EPRI Plant Engineering

Subject: Docket No. 99902021 – EPRI Comments on the Draft Safety Evaluation
for Topical Report 3002018337-P

Comments on Draft Safety Evaluation for DVR Topical Report

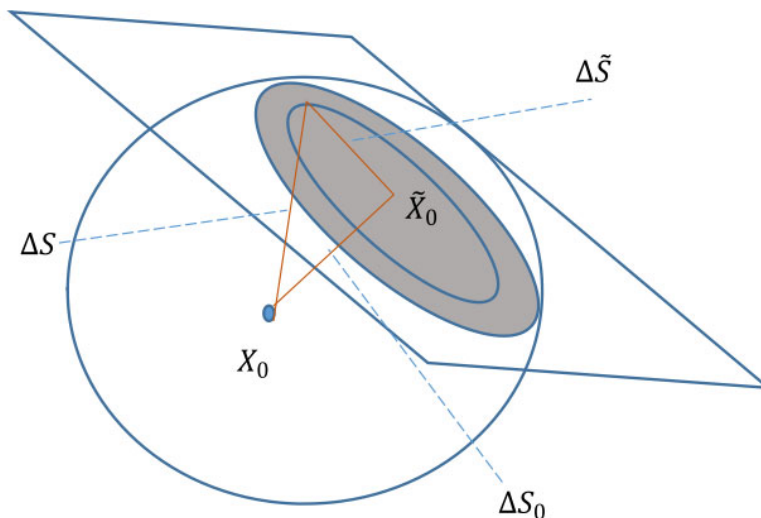
- Page 32: Section 3.5.2, second paragraph of page 32, the document switches here from discussing 0.5% of FW flow uncertainty to 0.5% of CTP uncertainty. Previously, the document made a distinction between what DVR calculates (FW flow) and what the plant computer estimates from that value (CTP). This paragraph should be consistent with section 3.4, paragraph 2, since it is referencing major/minor contributors. Consistency throughout would be useful, but not necessarily mandatory
- Page 36 states “an inherent assumption in applying the results from DVR is that the error in the reconciled means is smaller than the error in the measured means”. We don’t believe the topical report makes this assumption, so this should be revised to remove the phrase in quotations. However, this could possibly be proven mathematically. By inspection of (see Figure 6 and equation 3.10),

the true value lies on the plane (i.e. constraint equations) “slicing” through the ellipsoid. As shown on the figure, any point on the plan forms a right triangle. If the true value lies on the grey plane, the hypotenuse ΔS would be the measured error and $\Delta \tilde{S}$ would be the reconciled error. By using basic geometry, the hypotenuse will always be largest side on a right triangle. Therefore, the reconciled error will always be smaller than measured error. We don’t recall this question as an RAI, so this level of detail was never submitted to the NRC.
